RINGWOOD TOWN ACCESS PLAN SUPPLEMENTARY PLANNING DOCUMENT

The draft Ringwood TAP was published for public consultation between 18th October and 30th November 2010. Comments were received from 19 respondents. These are set out (in document order) below, together with the initial assessment of how the Council should respond to the comment.

Figure 2: Key facilities in Ringwood

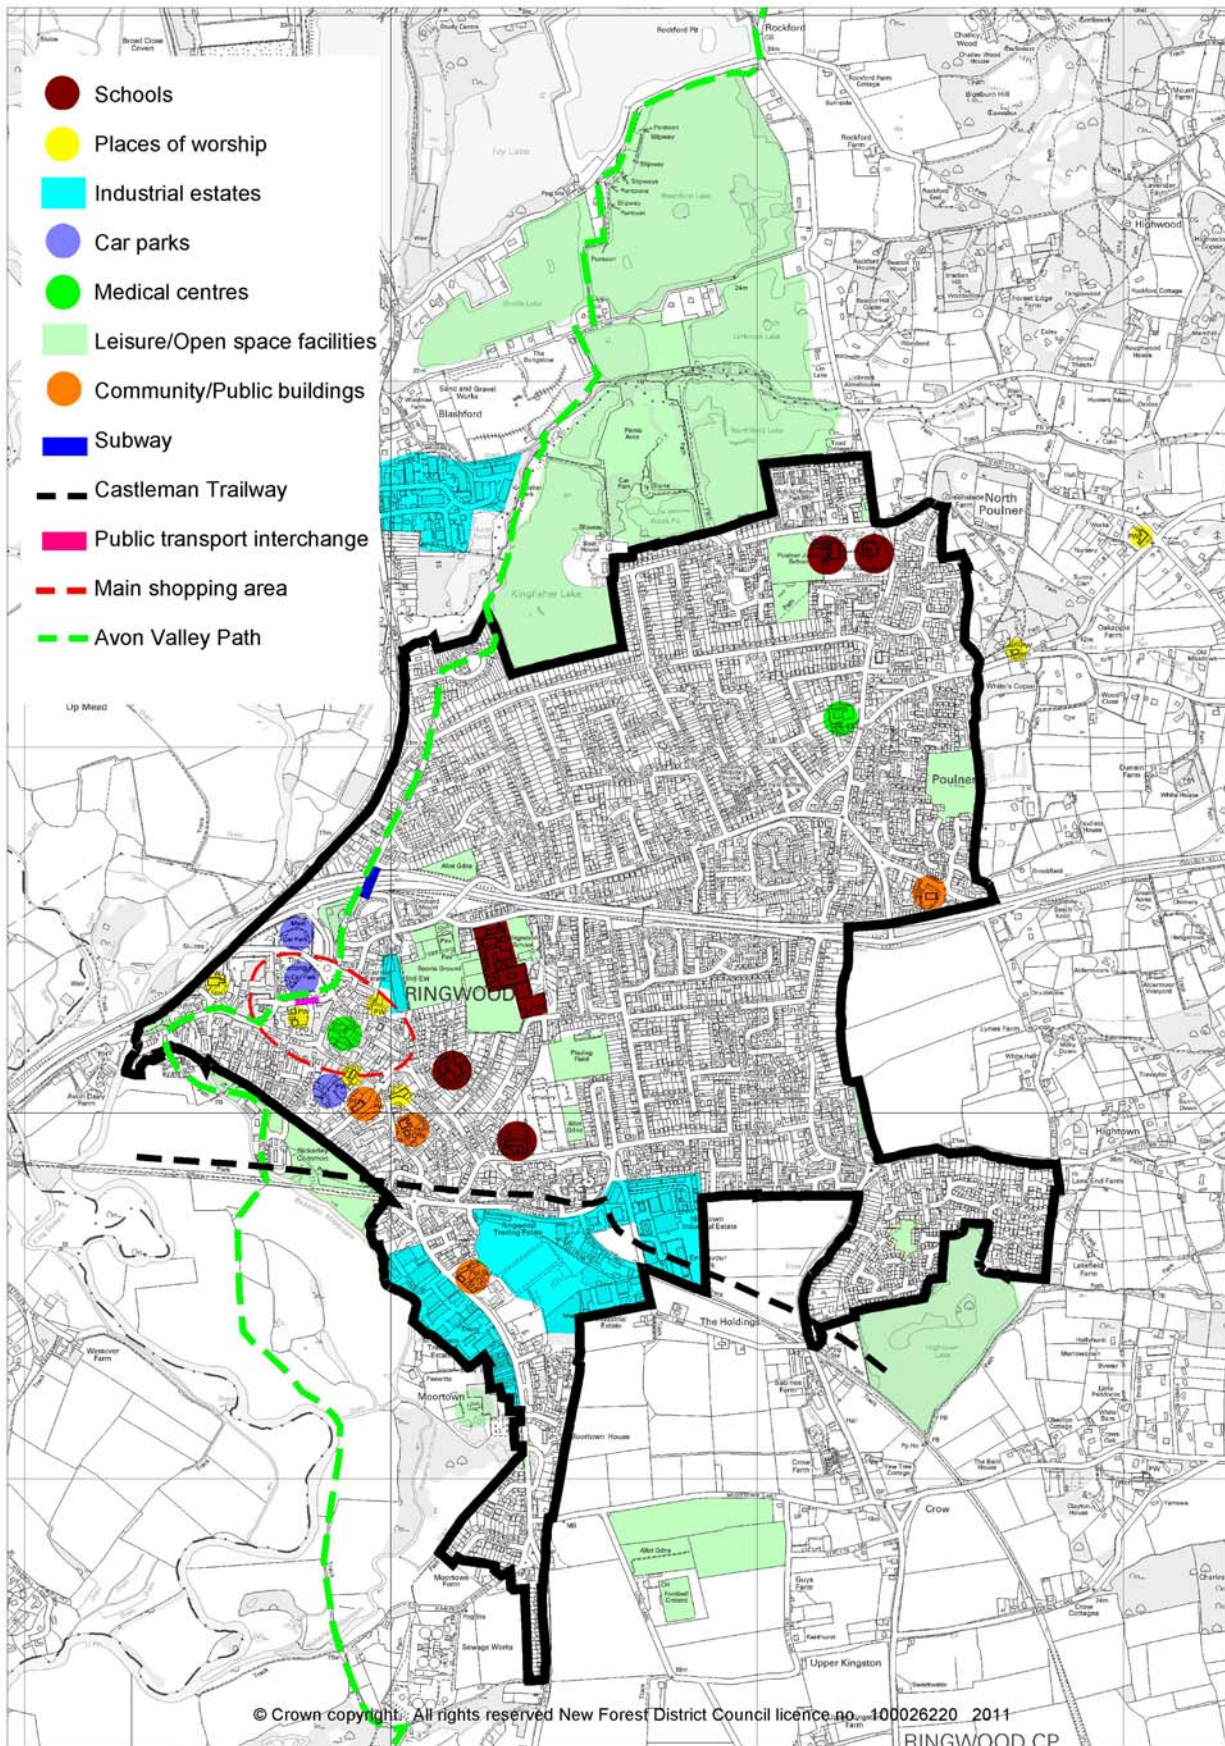
2.4	R18	Ringwood Town Council	The map of key facilities does not include much of the Town Council's leisure/open spaces facilities, e.g. Ash Grove Play Area, North Poulner Open Space, Toad Corner Play Area, 3 x allotment sites, 10 acre field, Jubilee Gardens, Danny Cracknell Pocket Park and The Mount. There is also a green blob over Moortown – could you confirm what this relates to please?	Add to plan.	Locations of facilities to be added as requested and plan enlarged. "Green blob" is a David Lloyd health and leisure club.

Map 1 Transport Schemes

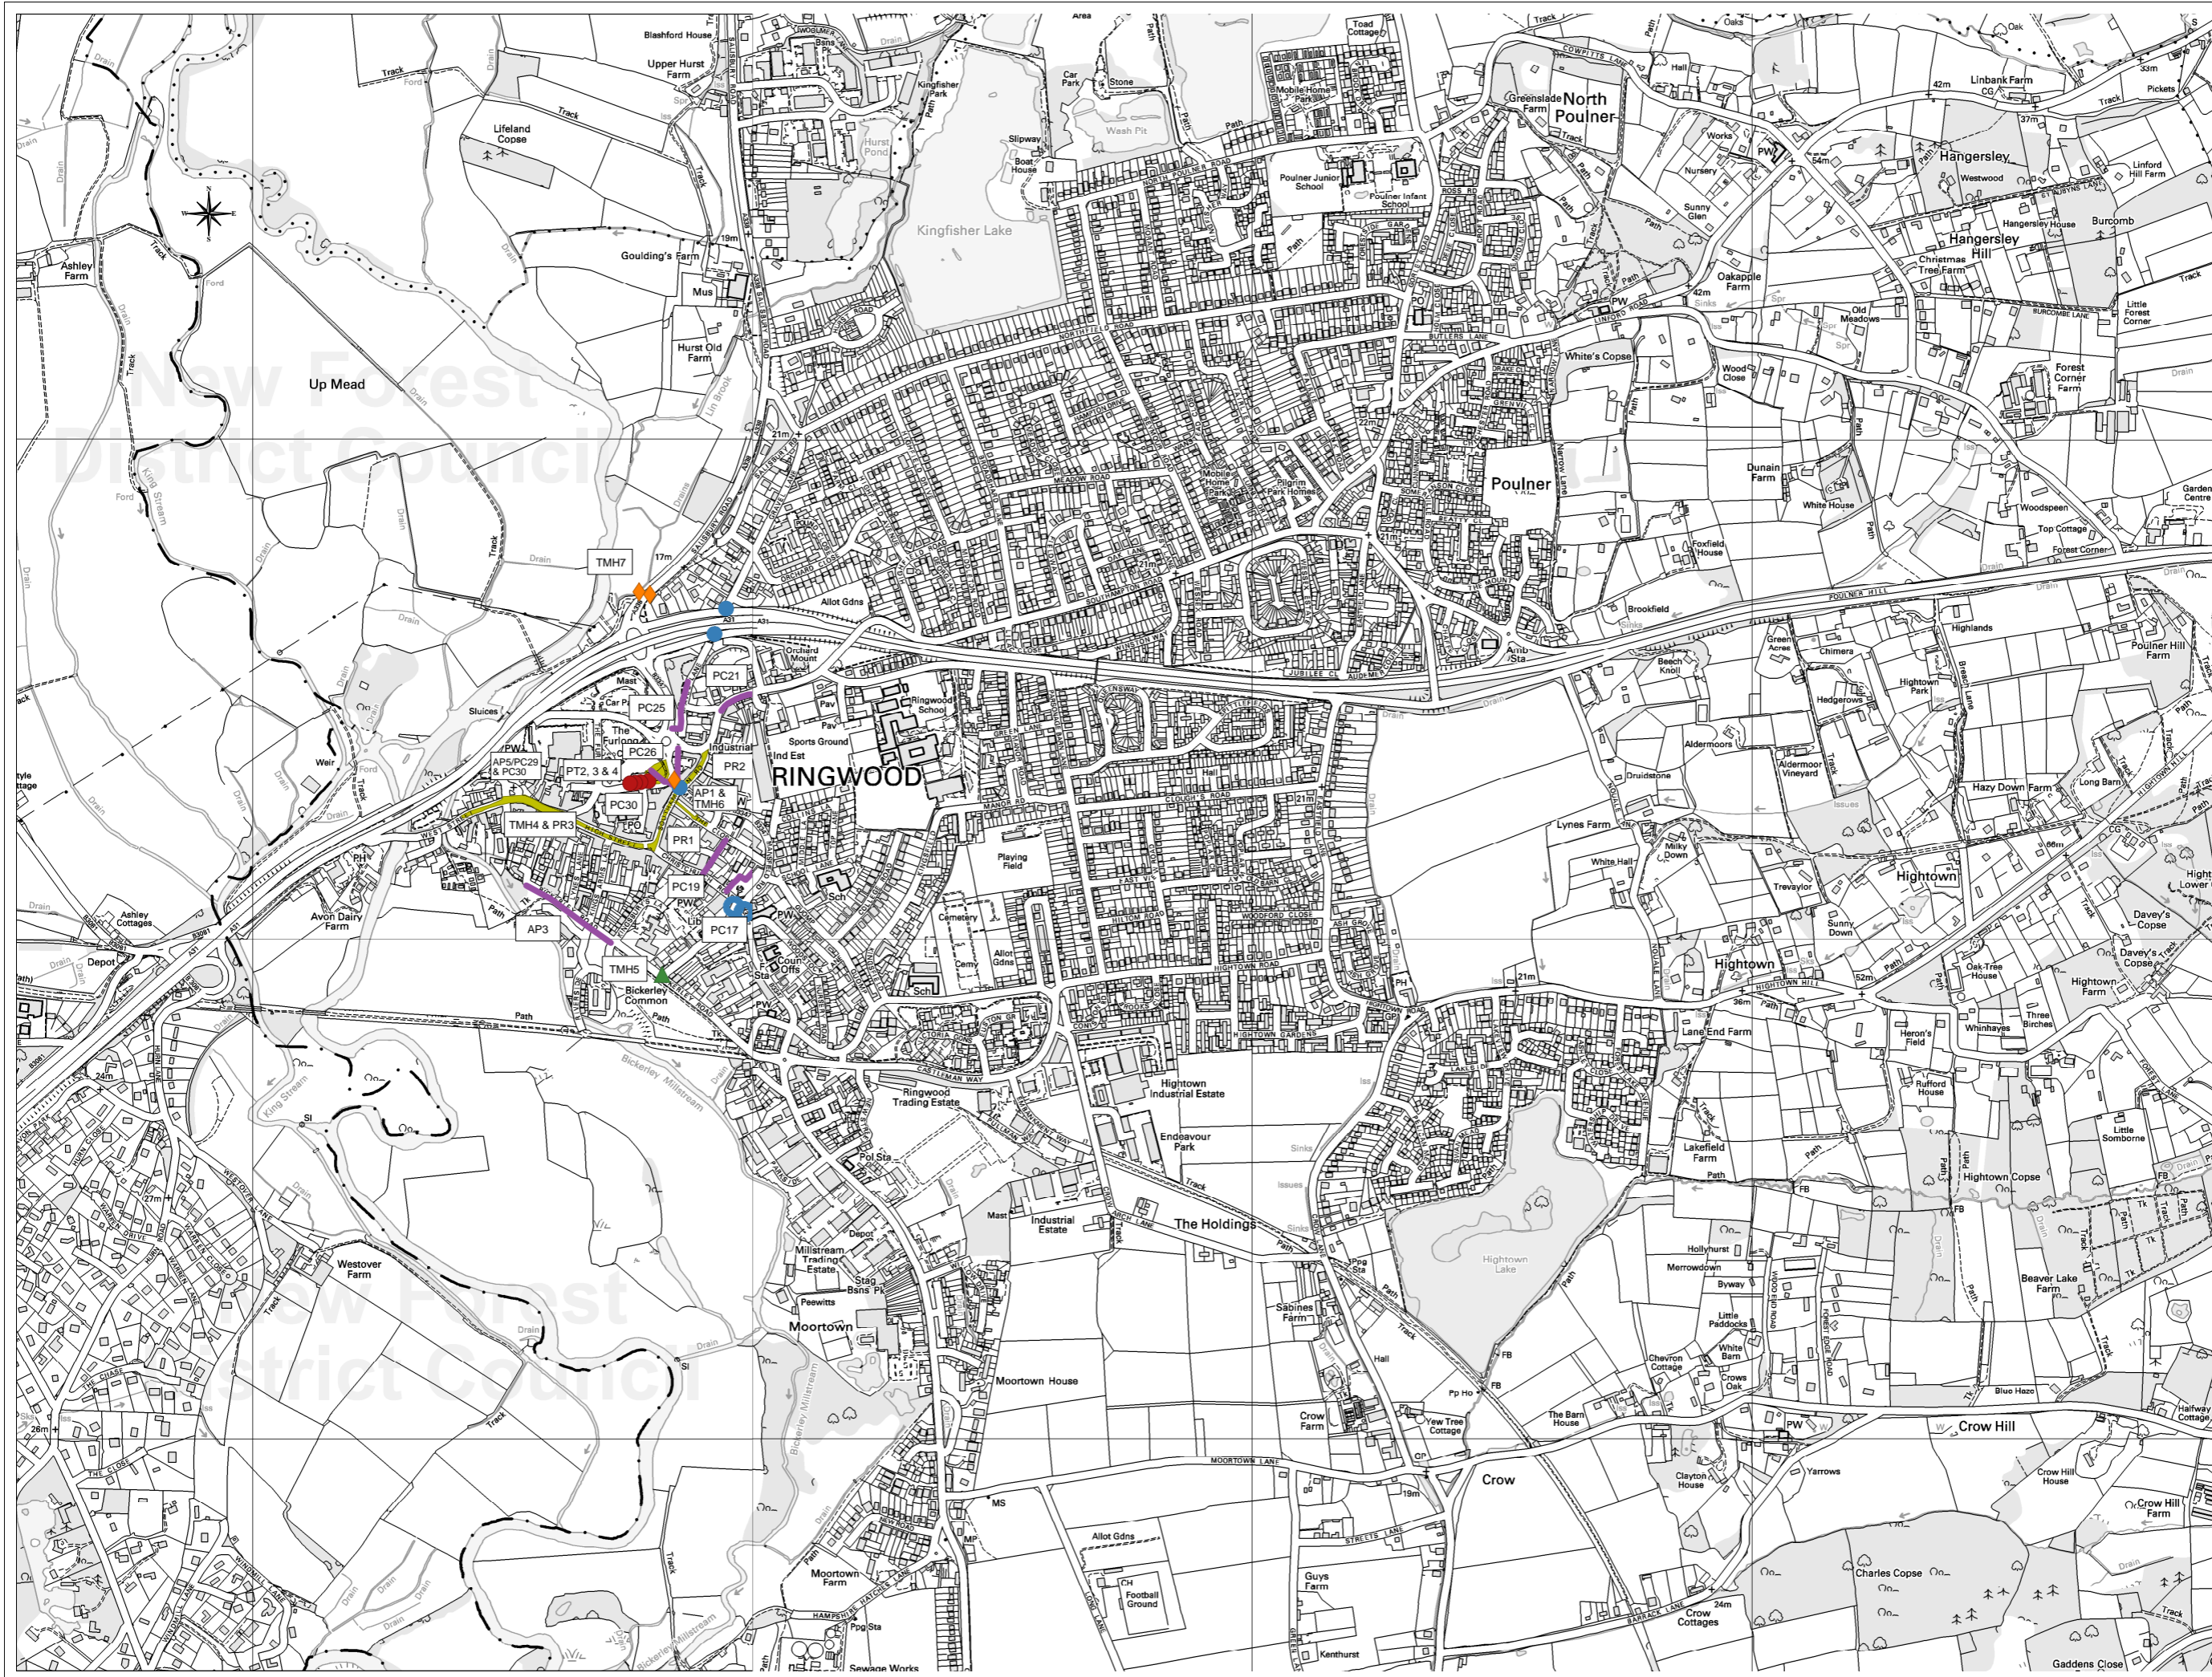
2.2	R16	Cllr Treleaven	Avon Valley Footpath: No reference made to this important pedestrian access route which traverses the Town. Amend the map R706(R)v2 accordingly and comment somewhere whether this footpath is fine as it is or whether there are any access improvements needed within the Town.	Make reference to path, review if path is satisfactory and add to plan in Appendix 3	Path is considered fit for purpose and changes will be made to the text to reflect this. It will also be annotated on the map as suggested.
